Re: *Jeanerette Lumber & Shingle Co., LLC v. ConocoPhillips Company, et al.*
16th Judicial District Court, Parish of Iberia, No. 134307, Div. "E"
DNR OC Legacy File No. 016-065

On behalf of the plaintiff, Jeanerette Lumber & Shingle Co., LLC ("Jeanerette" or "JLS"), in the above-captioned case, we respectfully submit these comments regarding the Site Investigation Report and Remediation Work Plan – Chevron Limited Admission, dated May 14, 2021, submitted by Environmental Resources Management Southwest, Inc. ("ERM") on behalf of Chevron U.S.A., Inc. ("Chevron").

Sketch of cypress root system extending four feet deep and exposed by erosion (Mattoon 1915).

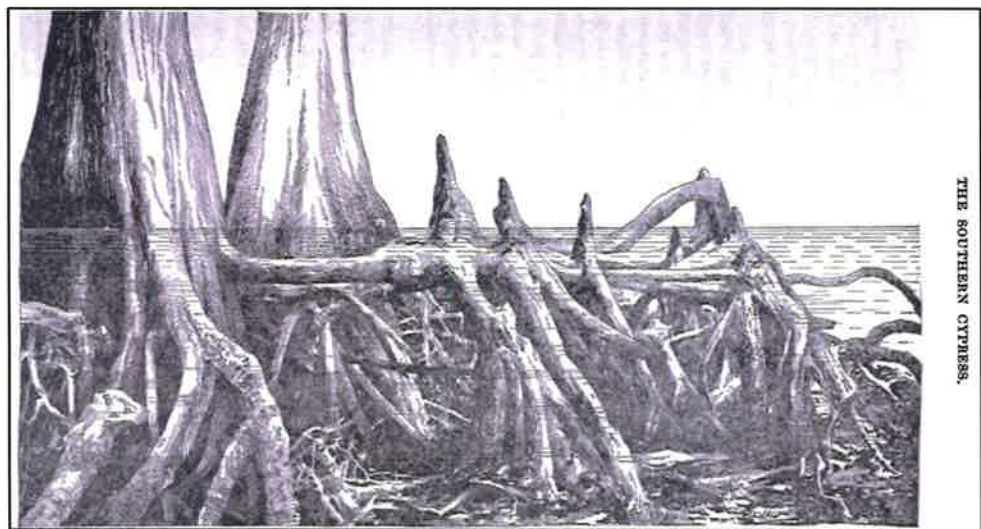
Not only is Chevron's root study methodology unreliable, it is inconsistent with observations of cypress tree root morphology. The USDA has noted that "The conical base of cypress divides below the surface into about six to ten strong descending and spreading roots, which provide a deep anchorage for the tree. The form suggests that of a mushroom anchor. In addition to the descending roots, a number of large laterals extend outward near the surface like cables and form the widely spreading and branching superficial root system that has been more commonly recognized."²⁶

There is no reason to doubt that based on ERM's boring logs, the Iberia Parish Soil Survey, and documented observations of cypress root morphology, that the cypress trees on the JLS property exhibit rooting depths much deeper than 24 inches.
